Nature of Work: 27 SQ T/O RESHEET REROOF W TILE

ROOF PLAN - GUAN

Subject: Structural Investigation Report of the Roof for the Residence located at 2 Vierra Court, Sacramento, CA 95831.

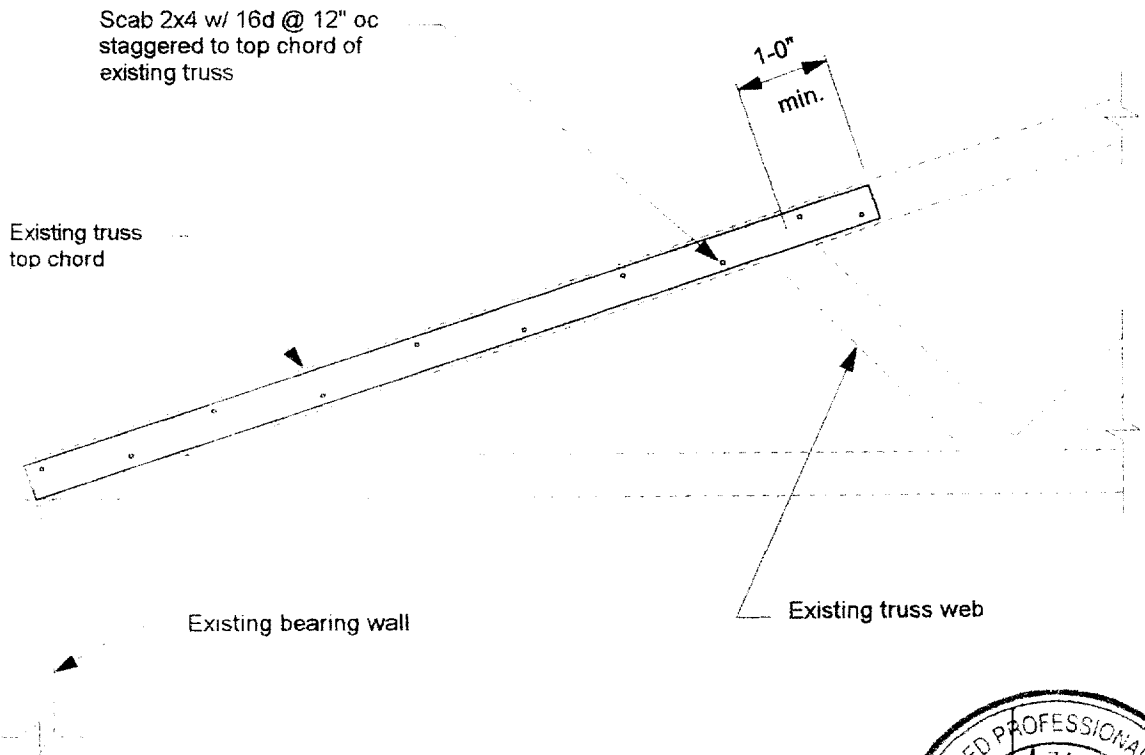
Roof:
The living area lacks sufficient structural capacity for the applied live and dead loads. The garage has sufficient structural capacity for the applied live and dead loads.

1. Scab a 2x6 DF#2 x 11'-6" long rafter to the top chord of the existing truss. See details 1 and 2.
